Access Compliance Report

Public Rights-of-Way

(Pedestrian Signals)

Intersection ID: N/A	Main Street:	Cross Street: N/A	Location: N/A
ADA ID: BE413E3F2801	Signal Type: Two Push Buttons-APS	Overall Compliance: No	Severity Score: BTN 1:N/A BTN 2: N/A No BTN: N/A
Codes/Mitigation Info/Possible Solution		Field Measurements/Component Compliance

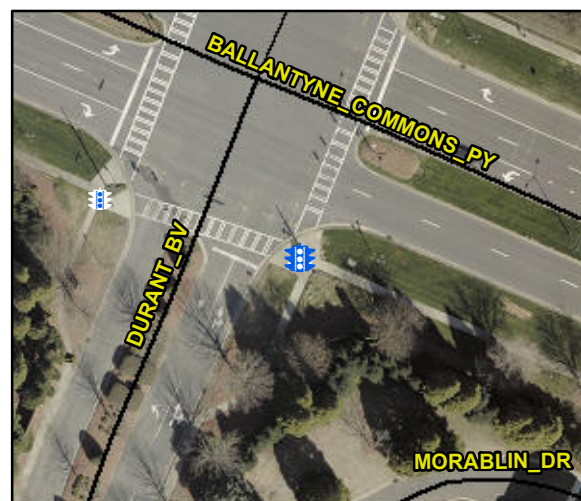
PROW/ADA: TMUTCD 4e.08, R404.3, R404.2, R404.7.1, R404.7.2,

Yes	B 1 Clear Xing Direction?	ClearlyMarked	Yes	B 2 Clear Xing Direction?	ClearlyMarked
	B 1 Crossing Direction	To NE		B 2 Crossing Direction	To NW
Yes	B 1 DistanceTo XWalk (in)	0.0	Yes	B 2 DistanceTo XWalk (in)	0.0
No	B 1 DistanceTo Curb (in)	102.0	No	B 2 DistanceTo Curb (in)	98.0
Yes	B 1 Diameter (in)	2.0	Yes	B 2 Diameter (in)	2.0

Possible Solutions: Replace Signal Push Button With APS Button on New Post. Remove & Relocate Sign.
